**NOTICE TO CONTRACTORS**  
**BID #1314-142**  
**Costco Intertie and Vista Grande Waterline**  
**PWP # CC-2014-096**

Addendum No. 3

Please make the following additions/changes/clarifications to the above referenced project. The following is based on Request For Information items received by March 5, 2014.

NO.		REVISIONS	DATE	STANDARD DETAILS FOR PUBLIC WORKS CONSTRUCTION		SECTION		
1		REDRAW	11/92vp	P.C.C. MEDIAN CURB		WASHOE		
2		Add notes	2/94vp			DRAWING NO.		W-17
3		Add note 5	12/11sw			DATE		11/92vp
						PAGE	33

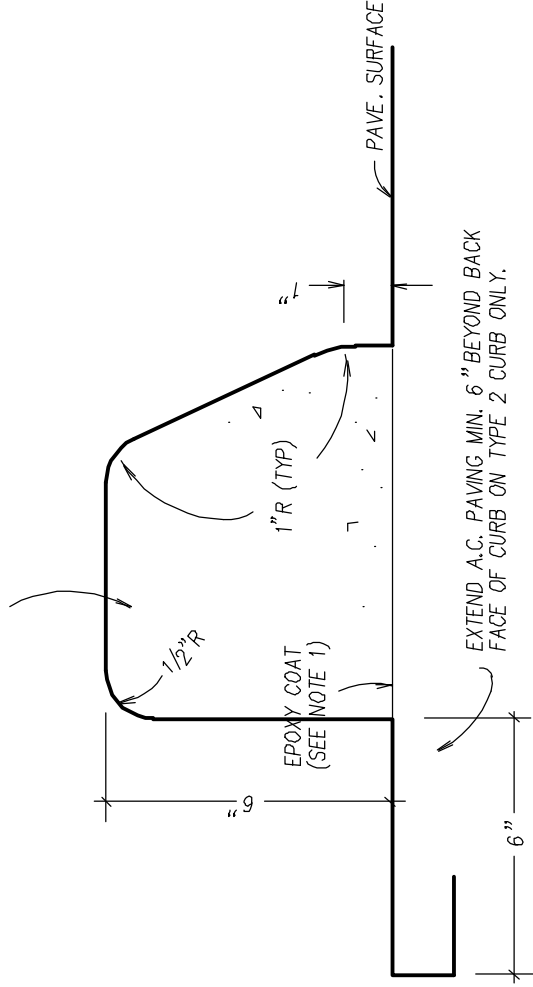
- d. *What standard detail should be used for this curb type?*

See attached detail.
